METROPOLITAN GOVERNMENT OF NASHVILLE AND DAVIDSON COUNTY

STAFF RECOMMENDATION 915 Petway Avenue November 20, 2013

Application: New Construction--Infill
District: Greenwood Neighborhood Conservation Zoning Overlay
Council District: 06
Map and Parcel Number: 08204038700
Applicant: Brandon Jaynes, Kudzu Real Estate
Project Lead: Melissa Baldock, melissa.baldock@nashville.gov

Description of Project: Application is to construct infill on a site that currently contains a non-contributing structure.

Figure 1. The house at 915 Petway Avenue will be demolished under a staff level permit.

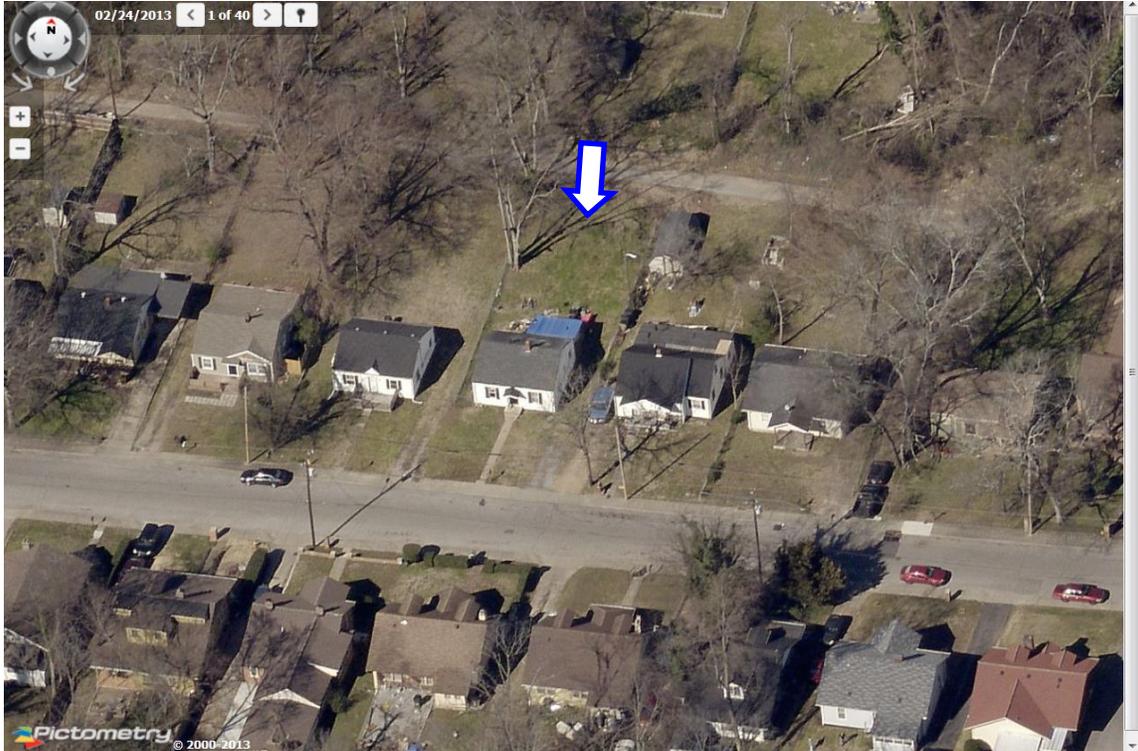
Background: Staff issued an administrative permit for the demolition of the non-contributing house at 915 Petway Avenue in November 2013 (Figure 1). The building lacks historic and architectural integrity and does not contribute to the historic character of the Greenwood neighborhood

sheet no.
A2

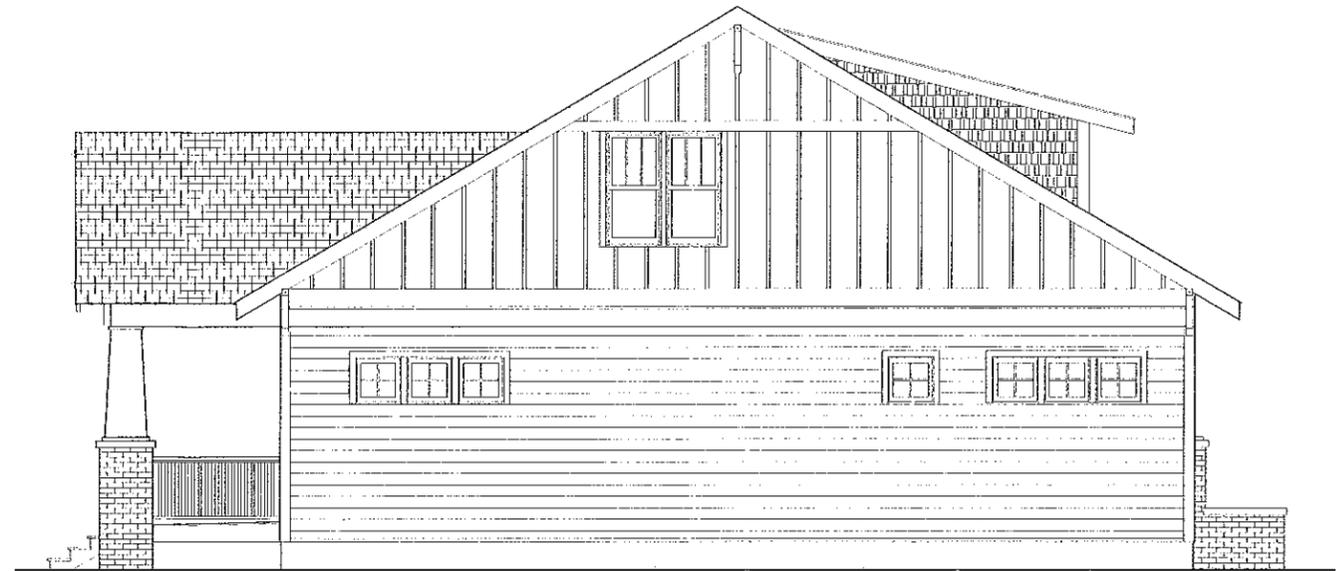
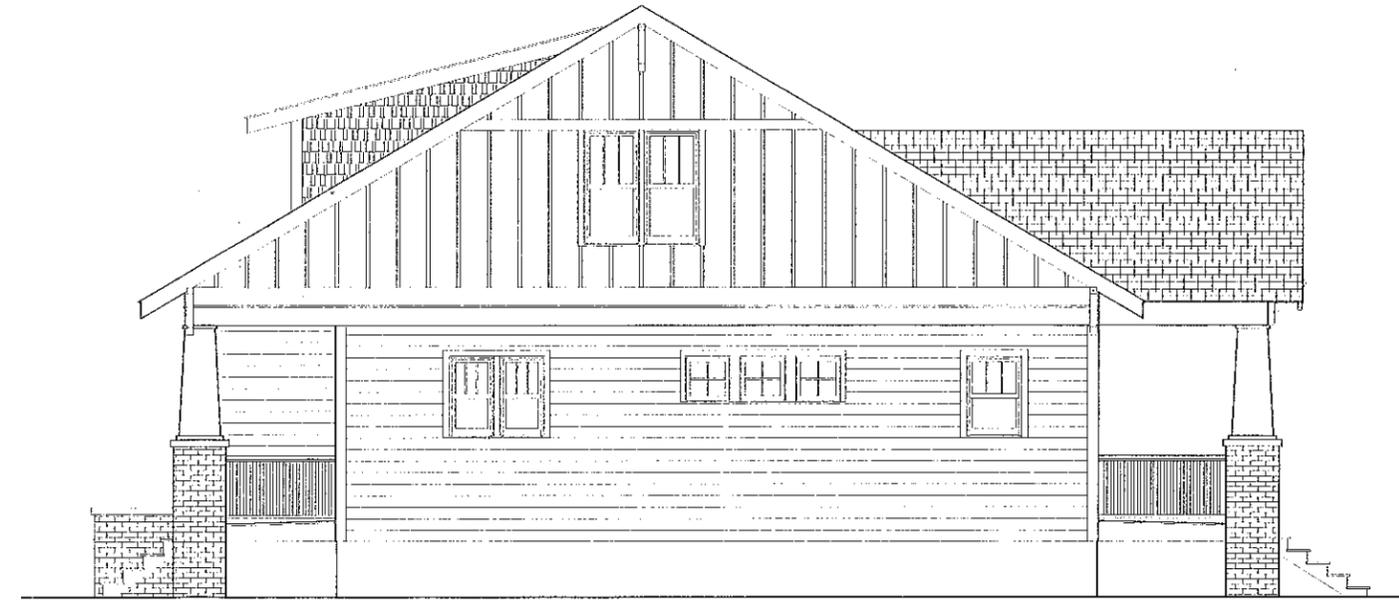
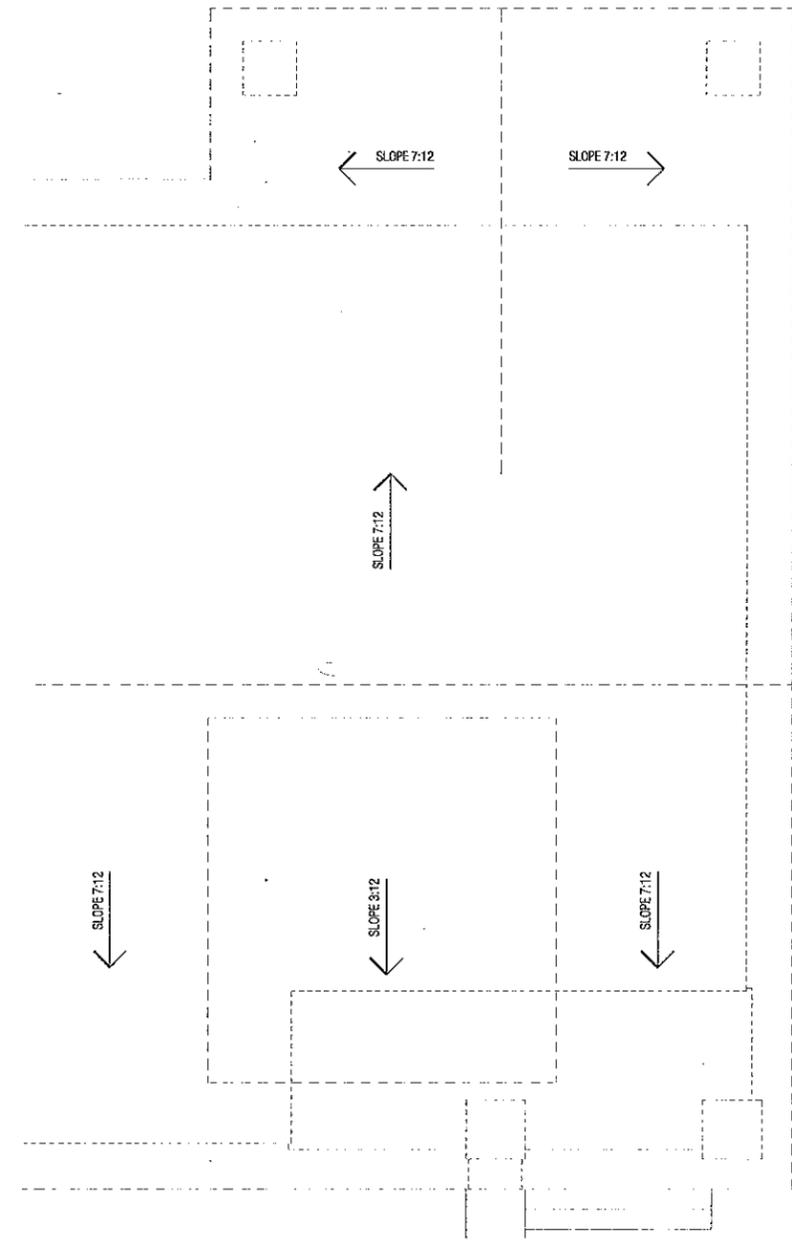
Height & Scale: The proposed structure is one-and-a-half stories tall. It will have an eave height of approximately nine feet (9') above the foundation line, and a ridge height of twenty-two feet, three inches (22'3") above the foundation line. The foundation is drawn to be three feet, eight inches tall (3'8") tall, but the applicant has indicated that foundation will be between one and two feet (1' – 2') in height. Staff asks that a condition of approval be that the foundation be no more than two feet (2') tall at the front of the infill. Staff finds that the overall height of twenty-four to twenty-five feet (24'-

Staff finds that the front porch column bases are unusually tall and are therefore out of scale with the historic context. Staff recommends that the column bases end at the porch floor level instead of continuing down to grade.

Roof form: The primary roof form is a side gable roof with a slope of 7/12. The front façade has a shed dormer with a slope of 3/12. The dormer is set more than two feet (2') behind the front wall of the house. The rear façade has a gabled roof over the porch, and that gable has a slope of 7/12. Staff finds that the proposed roof forms meet the historic context and meets section II.B.1.e. of the design guidelines.

Proportion and Rhythm of Openings: The windows on the front façade are generally taller than they are wide, thereby meeting the historic proportions of window openings. All double and triple window openings will have a four inch (4") mullion in between them. On the east side façade, staff asks that the window openings towards the front of the house be enlarged so that they are more of a typical size window. On both side facades, the windows on the ground floor are shorter than the gable windows on the second story. Typically, the Commission asks that windows on the ground floor be as tall or taller than those on the upper floors. In this instance, if the windows on the east side façade are enlarged to the size of the gable windows, staff finds the window proportions to be appropriate. On the east side façade, there is an expanse of sixteen feet (16') without a window or door opening. Staff finds this expanse to be acceptable if the window openings towards the front of the house are enlarged to be the size of those in the gable field. With the alteration of the windows on the east façade, staff finds the

1. A central walkway be included;
2. The foundation be no more than two feet (2') tall at the front;
3. The front porch column bases end at the level of the front porch;
4. Staff approve all windows and doors and the brick or stone sample for the front porch columns prior to purchase and installation;
5. The window openings on the east façade, towards the front of the house be enlarged so they are the size of the windows in the gable field.
